# United States Department of the Interior

Re: Draft Environmental Impact Report for the South Bay Substation Relocation Project, Chula Vista, California

The San Diego National Wildlife Refuge Complex (Complex) has reviewed the draft Environmental Impact Report (EIR) for the South Bay Substation Relocation Project located in Chula Vista, California. We offer the following comments for your consideration.

Figure 2: Enhancement Projects Location Map

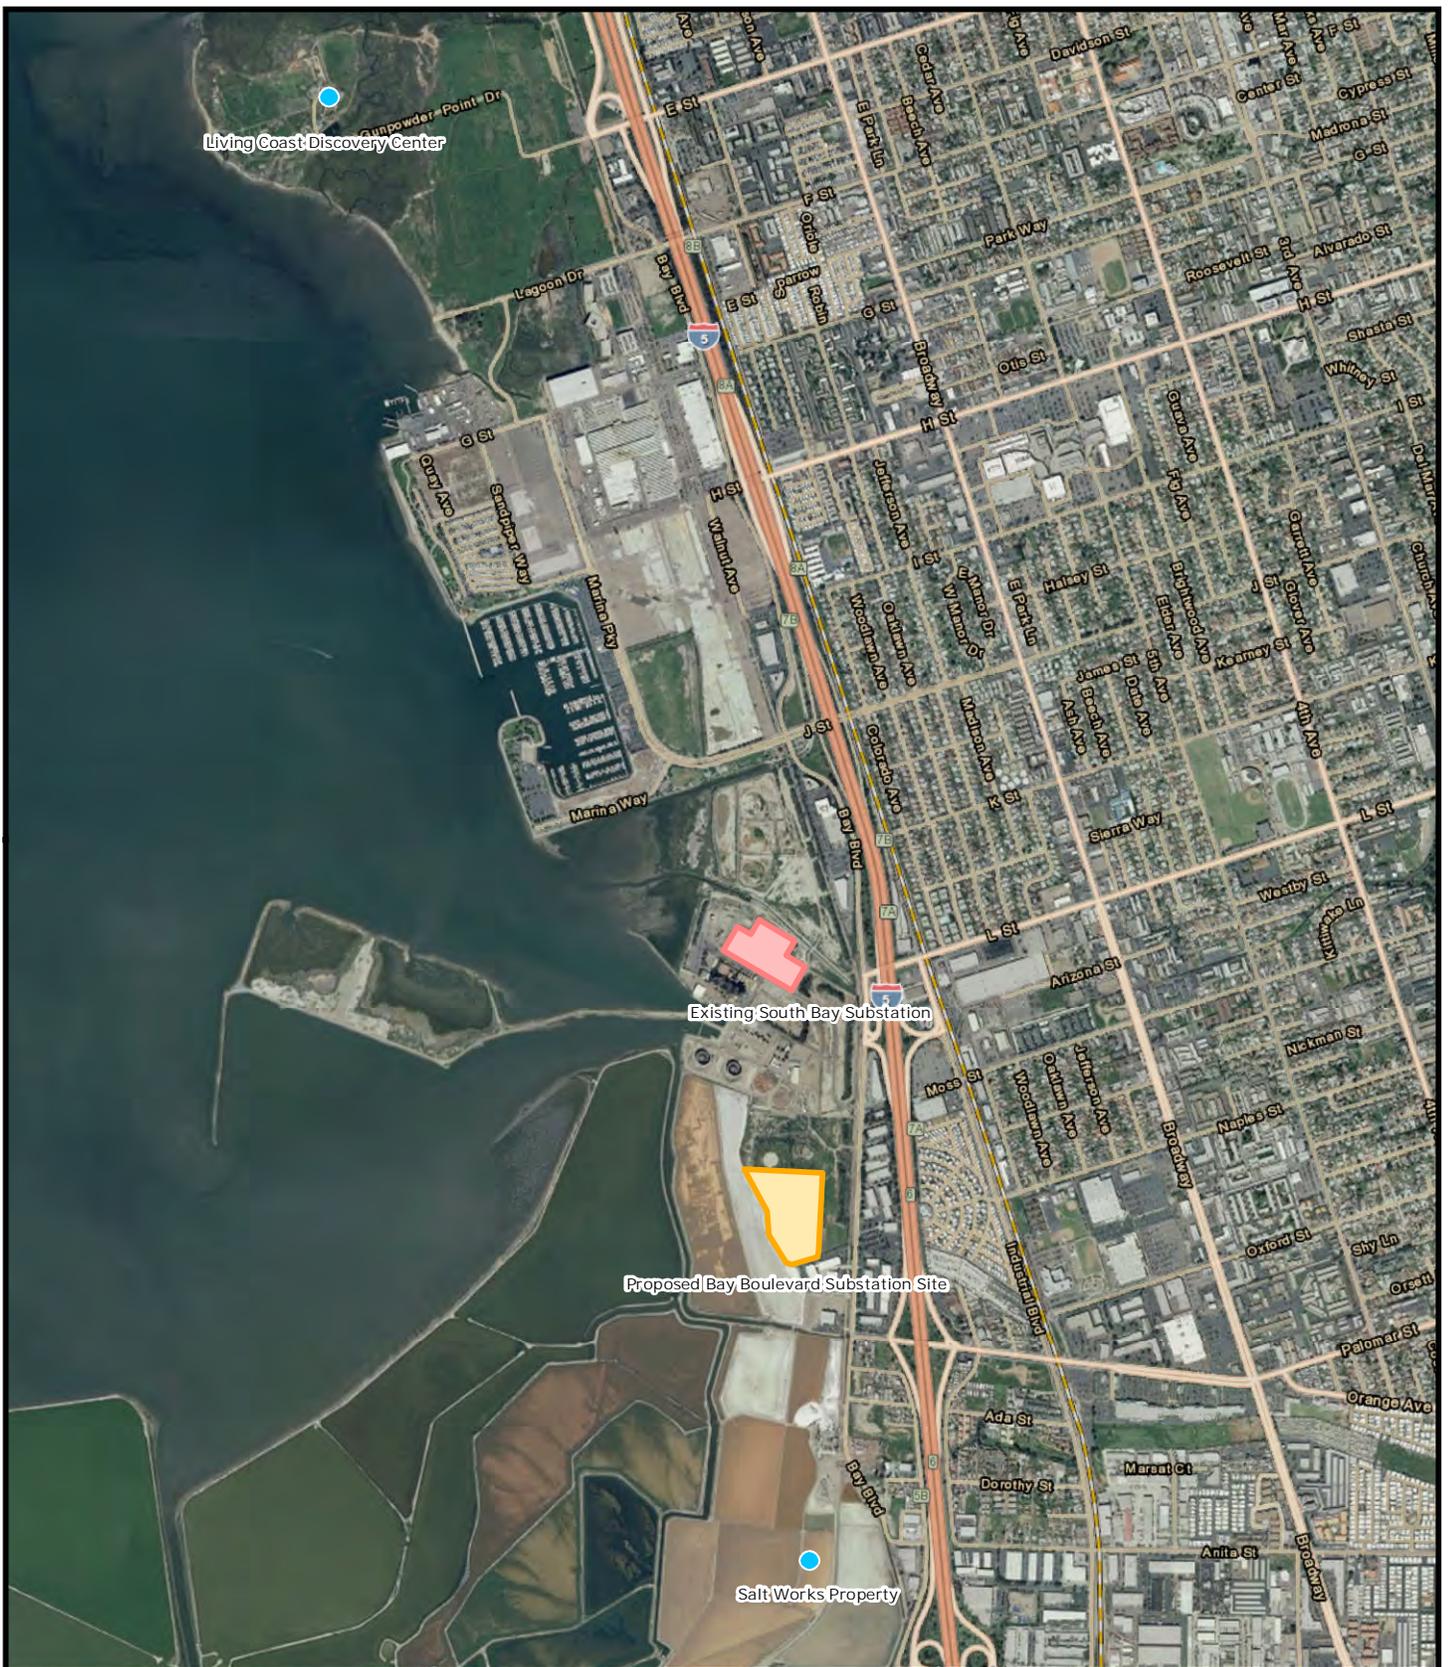
As provided in Section 2.1.1 Implementation, the Center is an existing nature Center that provides a living-museum experience while promoting coastal resource conservation and environmental stewardship through education. Figure 2: Enhancement Projects Location Map depicts the location of the Center in relation to the Bayfront Enhancement Alternative site. Providing funding to assist with the continued operation of the Center would not result in any new impacts to resources because the funding provided by SDG&E will allow the Center to continue to operate at existing levels within an existing buildings and facilities. No expansion of the Center would be funded by SDG&E's endowment. Funding the continued operation of the Living Coast Discovery Center would offer the sustained low-cost visitor-serving benefits that are provided by the Center, including an opportunity for the public to access coastal marsh areas that would not otherwise be available, and exposure of the public and schoolchildren to the Bay's wetland and marsh habitats and wildlife for coastal recreation and educational opportunities. Contributing funding to the Center would comply with state and local policies, including complying and advancing the policies established in the California Coastal Act. In addition, as previously noted, this funding would help protect and encourage the continued benefits that the Center offers by providing a lower-cost visitor/recreational facility for the public, in furtherance of Section 30213 of the Coastal Act, resulting in a net benefit to recreation.

**Figure 8: Construction Vibration Amplitudes**

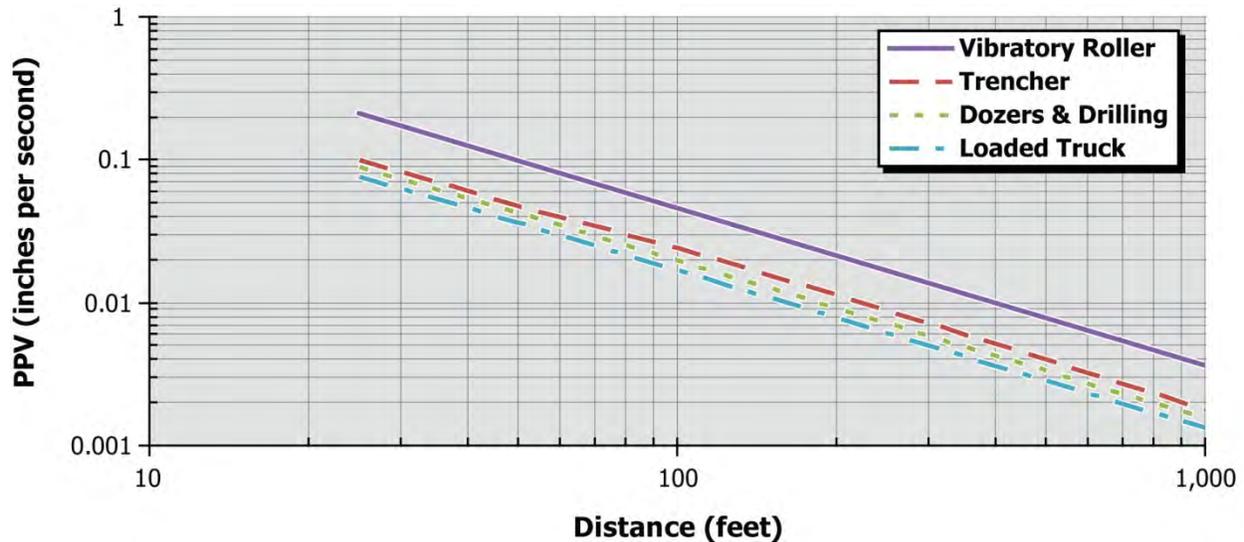
As depicted in Figure 8: Construction Vibration Amplitudes, at a distance of approximately 80 feet construction equipment would generate vibrations with an amplitude of less than 0.03 inch per second. This is below the potentially significant level of 0.032 inch per second. As a result, impacts from vibration would be less than significant.
